SUBJECT: ISSUANCE OF AMENDMENTS (TAC NOS. M89092, M89093, M89072 AND M89091)

The amendments revise the technical specifications (TSs) to include a maximum moderator temperature coefficient (MTC) of +7 pcm/°F and move the control of the cycle specific MTC from the TSs to the operating limits report. Our review also approves the methodology proposed by ComEd for ensuring that the plants continue to meet the anticipated transient without scram (ATWS) rule (10 CFR 50.62) during operation with cycle specific MTCs.

COMMONWEALTH EDISON COMPANY

BYRON STATION, UNIT NO. 1

FIGURE 3.1-0  
MODERATOR TEMPERATURE COEFFICIENT vs. POWER LEVEL

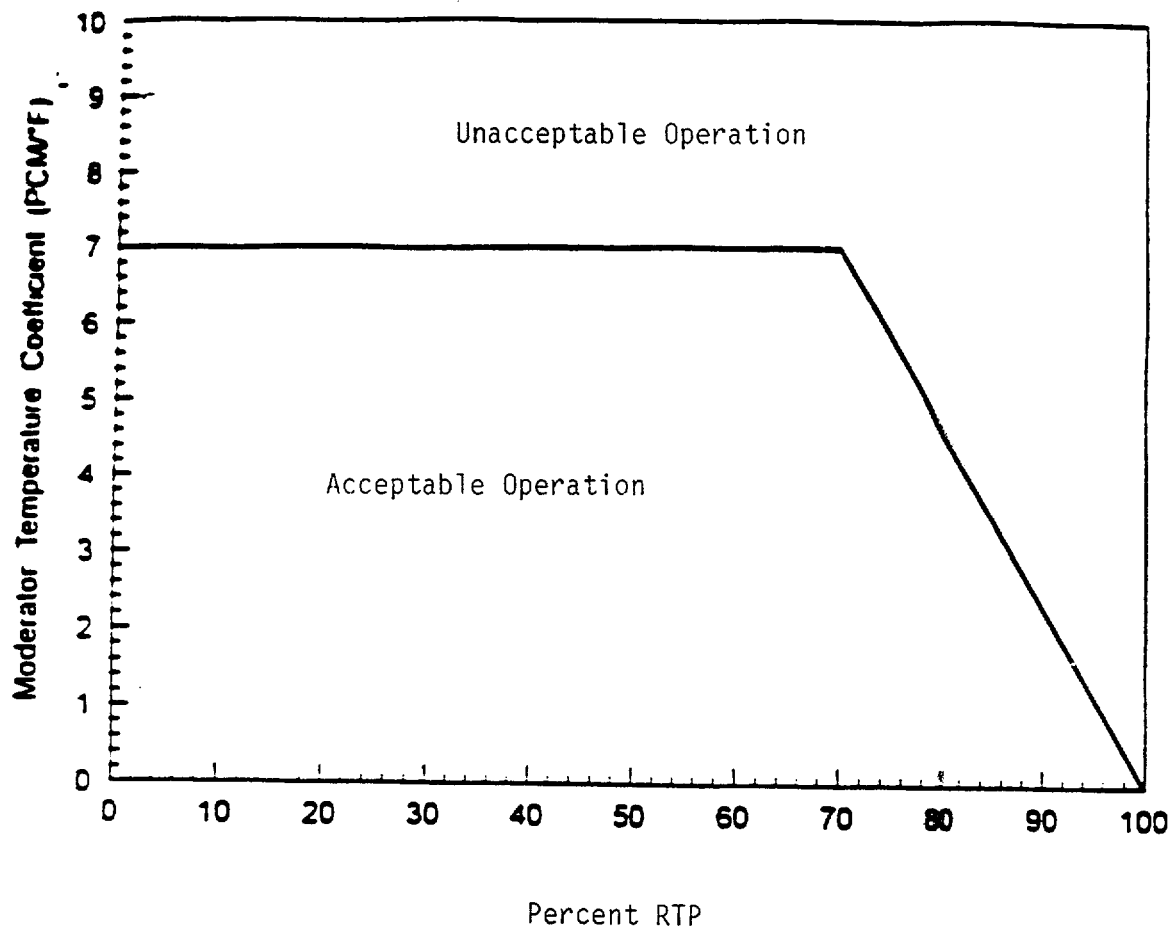
3.1.1.3 The moderator temperature coefficient (MTC) shall be within the limits specified in the Operating Limits Report (OLR). The maximum upper limit shall be less than or equal to that shown in Figure 3.1-0.

(2) TS 3.1.1.3; Moderator Temperature Coefficient, was changed to show that the MTC limits are now to be specified in the Operating Limits Report (OLR), with a maximum upper limit given in Figure 3.1-0 of the TS. This provides for a +7 pcm/°F coefficient approved based on an analysis of transients during the initial portion of the staff review and now based on the licensee's methodology for meeting the ATWS rule. There are changes to the Action statements to indicate the limits are now in the OLR. Similar changes referring to the OLR are also in the surveillance section. The movement of MTC limits to the OLR is within staff approved practice.

FIGURE 3.1-0

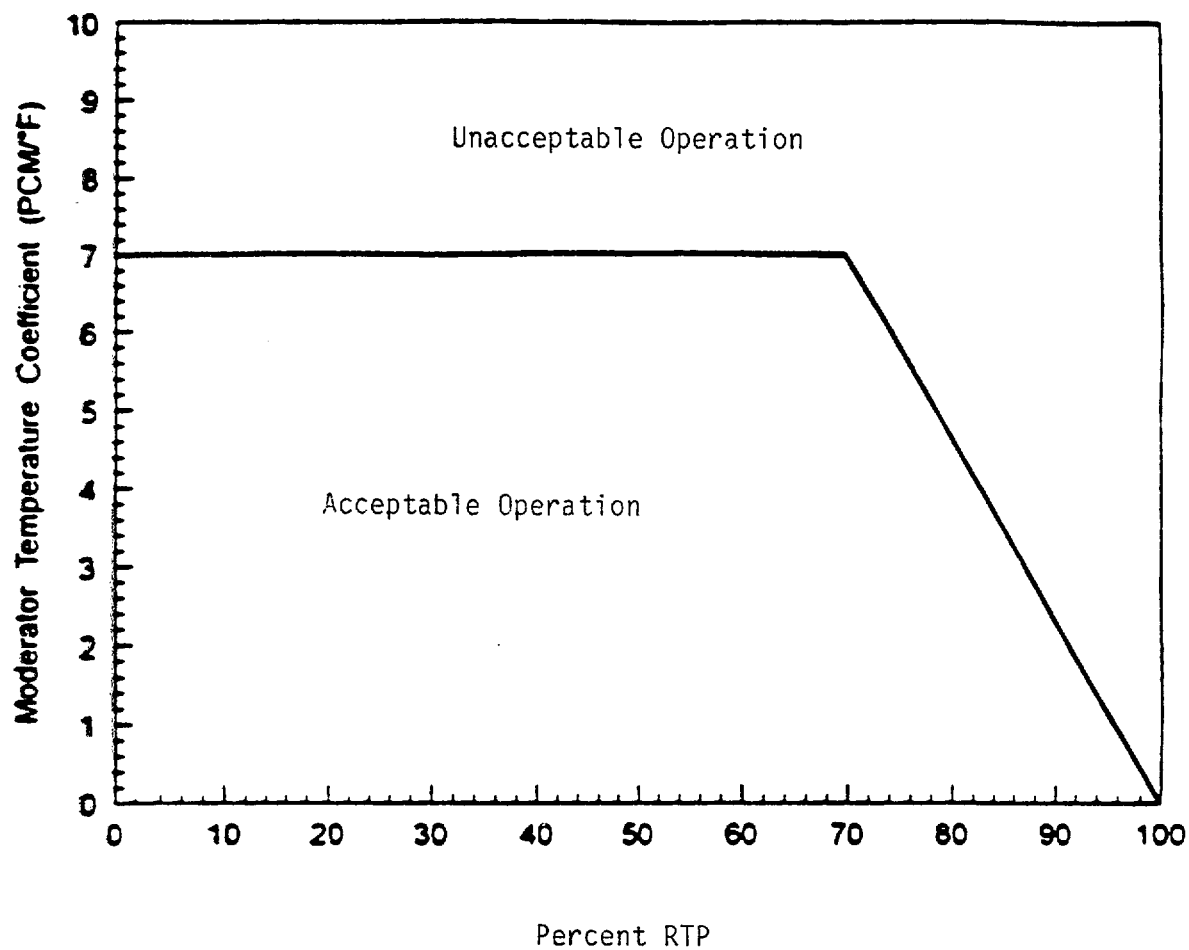
3.1.1.3 The moderator temperature coefficient (MTC) shall be within the limits specified in the Operating Limits Report (OLR). The maximum upper limit shall be less than or equal to that shown in Figure 3.1-0.
